CITY OF SANTA ANA

Application Description: Expanding existing unit 500 into 550 & 555: Adding demising walls, locker rooms, add non-bearing partitions, realign ceiling and mechanical systems

TENANT IMPROVEMENT PLAN CHECK COMMENTS

PLAN CHECK NO:	10173124	
PROJECT ADDRESS:	200 W Santa Ana Blvd Unit# 500	
PLAN CHECK ENGINEER:	Mazarji, Zac	TEL: 714 647-5831
		FAX: 714 647-5897
TYPE OF CONSTRUCTION:	I A, SPK	
OCCUPANCY CLASSIFICATION(S):	B	
PLAN CHECK DATES:		REMARKS/RECHECK ITEMS:
APPLICATION	9/6/2011	
INITIAL REVIEW	9/7/2011	
EXPIRATION	3/4/2012	
RECHECKS:	1. 2. 3.	PROJECT APPLICANT CONTACT PERSON: Fraser McClellan
VALUATION:	\$300,000.00	TEL: (714)897-3382
FLOOD ZONE:	X-0602320276J	FAX: (714)897-5952
		EMAIL: Fraser@FMAcorp.com

TYP. CEILING SUSPENSION

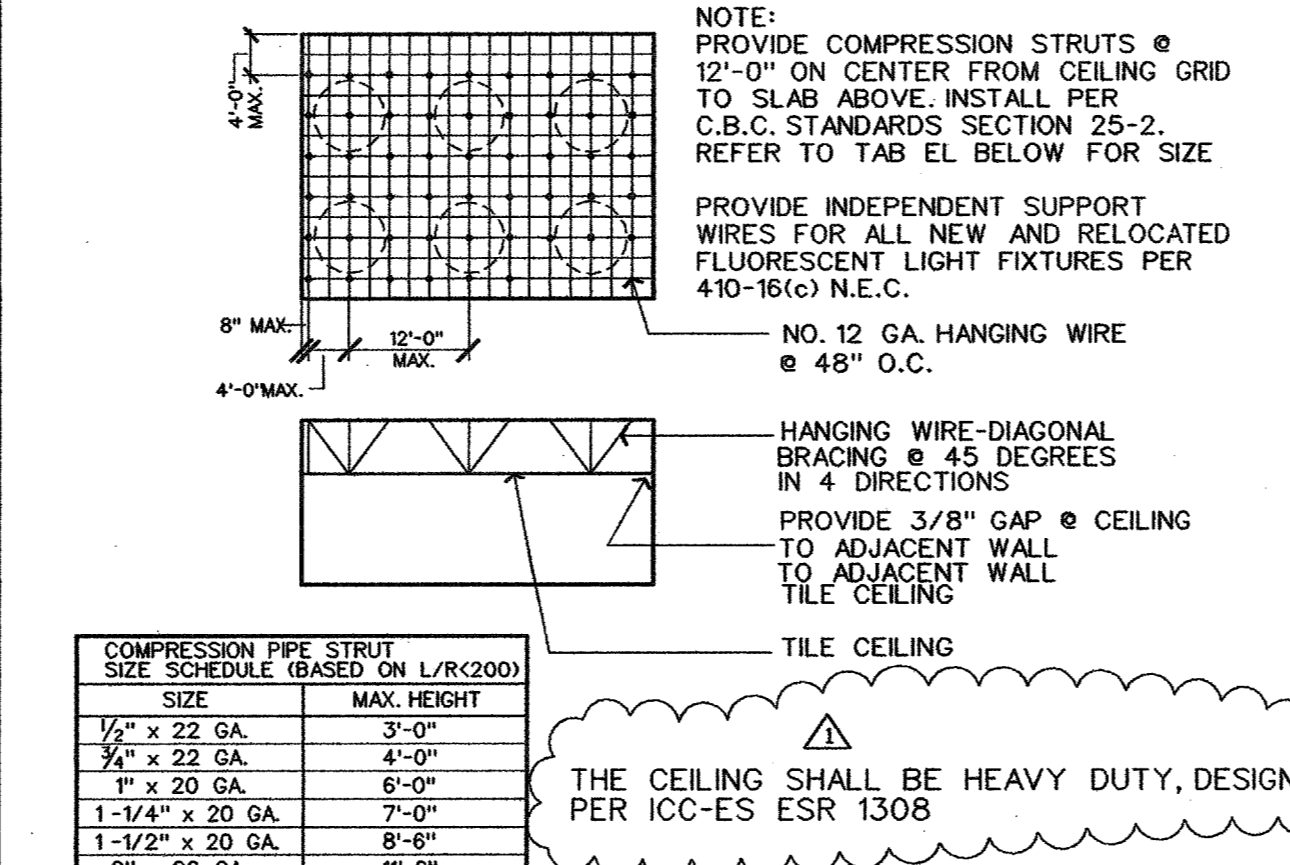
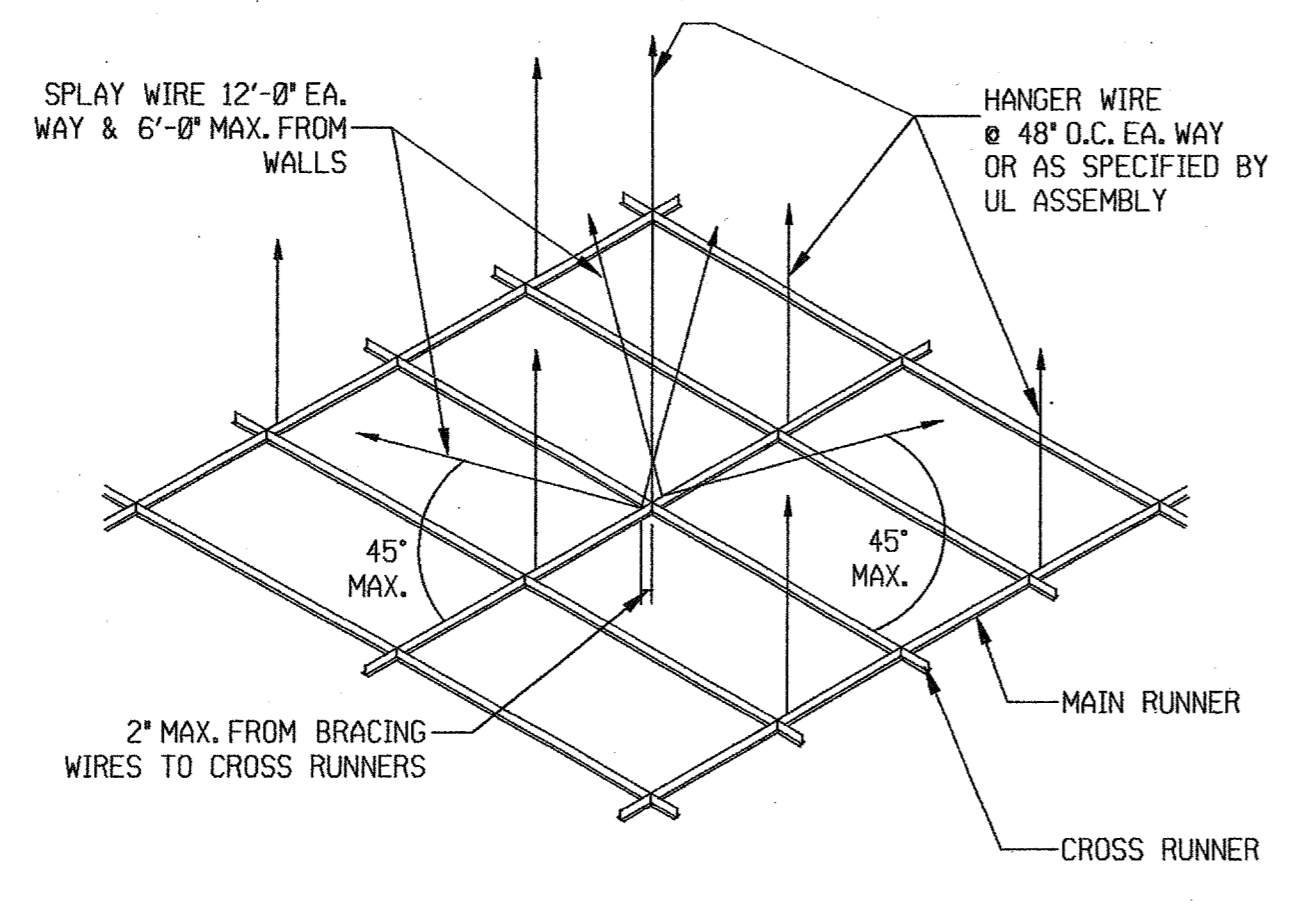
50. Provide complete structural calculations and drawings for suspended ceiling systems showing compliance with CBC Sections 711.3.1, 803.9, 1613, and 1705 (special inspections) and ASTM C635 and ASTM C636. The reflected ceiling plan and details must show compliance with CBC Sections 711.3.1, 803, 1613, and 1705 (special inspection) for suspended ceiling systems.

- REFER TO DETAILS 7, 8, 9, AND 10 ON SHEET AD-1 FOR SUSPENDED CEILING DETAILS.
- WHERE MULTIPLE LIGHT SWITCHES, DIMMERS OR OTHER LIGHT CONTROLS OCCUR, GANG THEM TOGETHER. NOTIFY FRASER MCCLELLAN & ASSOCIATES IN THE EVENT OF ANY EXCEPTIONS.

SHOWER STALL DETAILS AND CLEARANCE REQ. 4

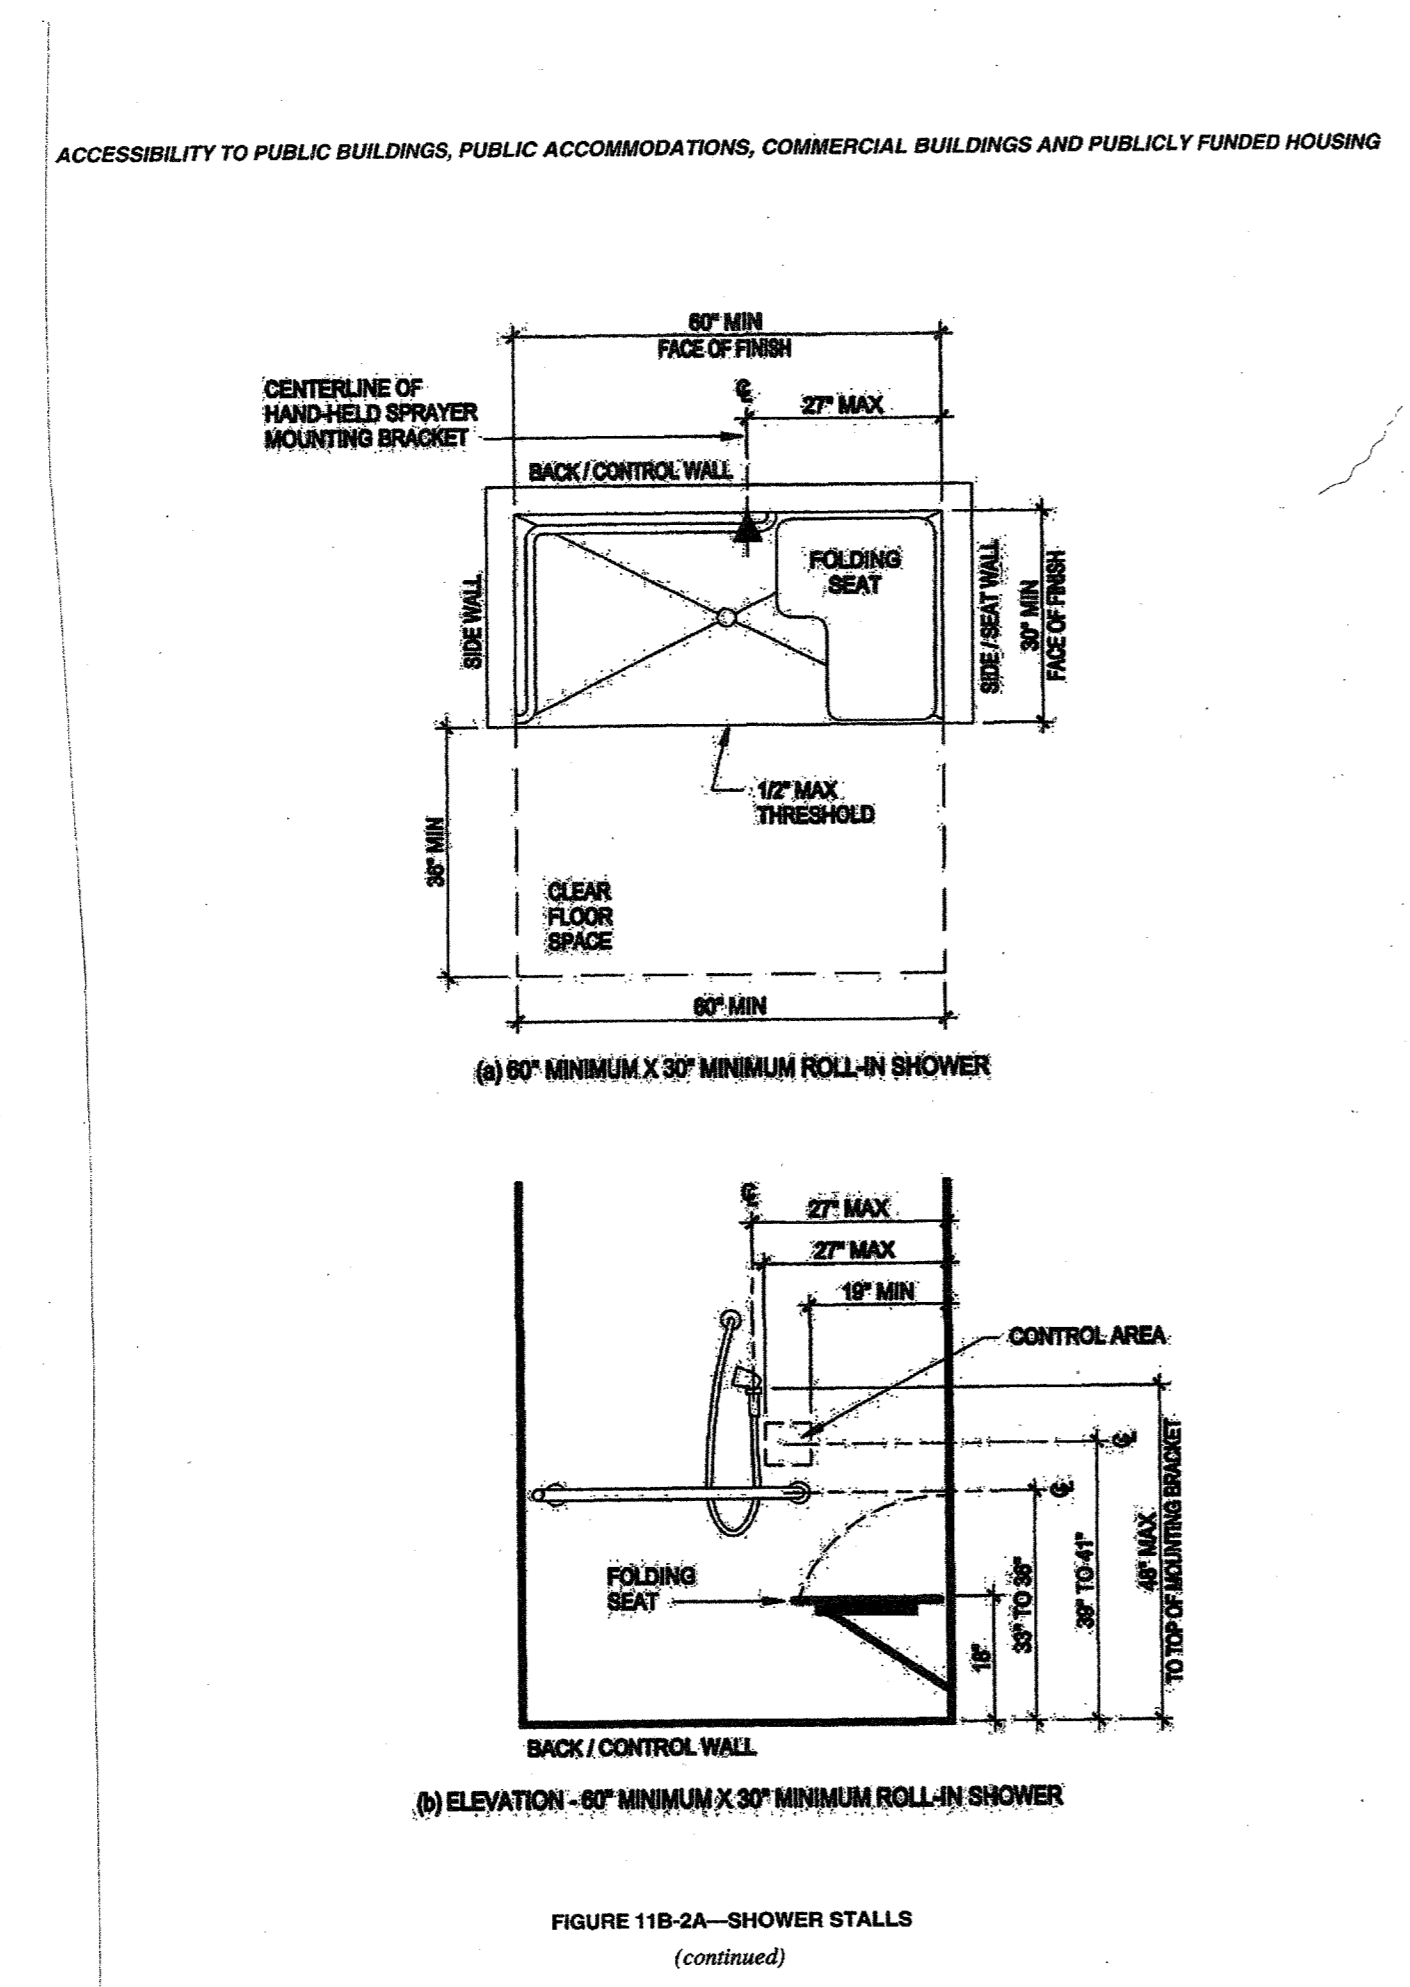
38. Provide enlarged and legible drawings to show accessible shower rooms. *ADDED ON AD-2*

- NEW PRE-FABRICATED ADA COMPLYING FIBERGLASS SHOWER ASSEMBLY. ASSEMBLY TO HAVE FOLDING SEAT AND PROPER MIXING VALVES AND DUAL SHOWER HEADS AS REQUIRED. REFER TO DETAIL 4 ON THIS SHEET SHOWER PLAN AND ELEVATION. GENERAL CONTRACTOR SHALL PROVIDE MANUFACTURERS SHOP DRAWINGS FOR REVIEW AND APPROVAL.
